DEPARTMENT OF TRANSPORTATION**Federal Aviation Administration****14 CFR Part 39**

[Docket No. 99-NM-65-AD]

Airworthiness Directives; Boeing Model 747 Series Airplanes Equipped With Pratt & Whitney JT9D-70 Series Engines

ACTION: Notice of proposed rulemaking (NPRM).

Figure 1

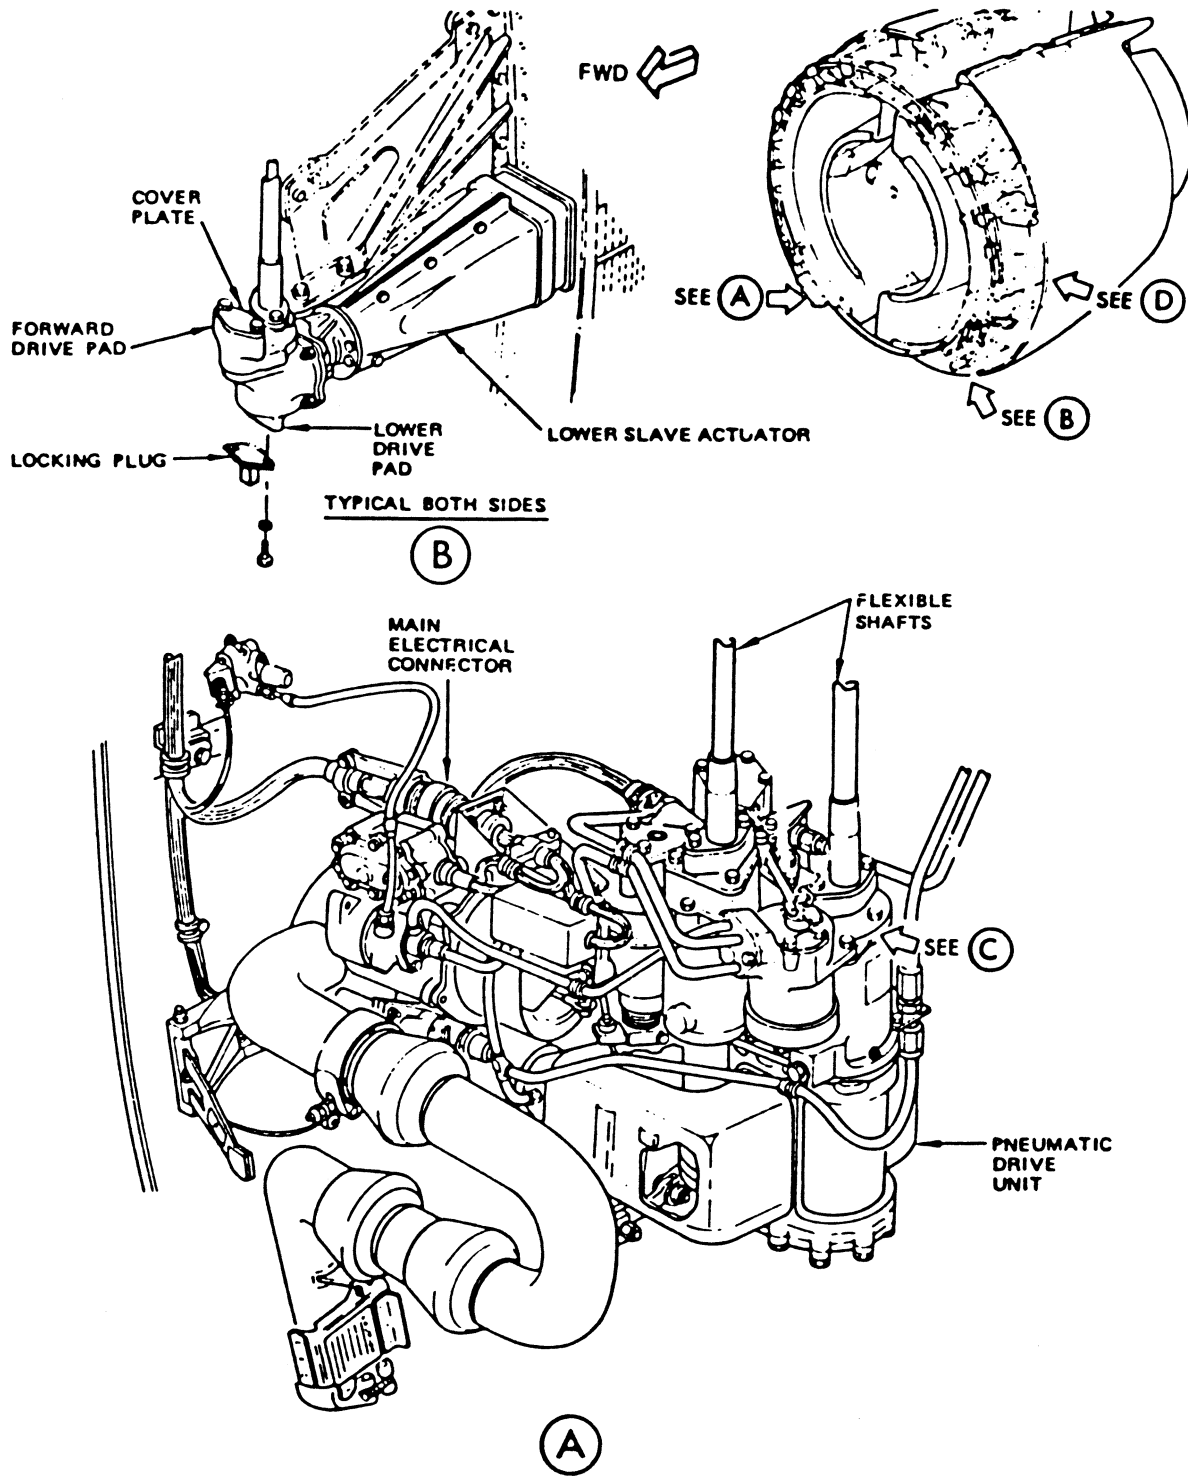
(f) Within 4,000 hours time-in-service after accomplishment of paragraph (e) of this AD: Perform a functional test to detect discrepancies of the additional locking system on each thrust reverser, in accordance with Appendix 1 (including Figures 1 and 2) of this AD. Prior to further flight, correct any discrepancy detected, in accordance with the procedures described in the Boeing 747 Airplane Maintenance Manual. Repeat the functional test thereafter at intervals not to exceed 4,000 hours time-in-service.

- (4) Depress drive unit latch operating arm and retain by engaging latch arm (detail C).
- (5) Disengage stow latch hook on left and right thrust reversers (detail D).
- (6) On either lower slave actuator (detail B), either remove coverplate from forward drive pad or remove locking plug from lower drive pad.
- (7) Move left-hand sync-lock lever to the unlocked position.
- (8) Using appropriate drive adapter (196K8004-1 at forward drive pad or 196K8004-3 at lower drive pad), attempt to manually deploy sleeves.

- (15) Rotate actuator gearshaft to fully stow the sleeves.
- (16) When translating sleeves reach stowed position, check that stow latch hooks have engaged fixed hooks on both sides (detail D).
- (17) Depress latch operating arm and disengage latch arm (detail C); allow latch arm to raise.
- (18) After releasing arm, verify latch engagement by attempting to rotate feedback gear on drive unit using 1/4-inch square drive; gear shall not rotate in excess of 0.1 of a turn.
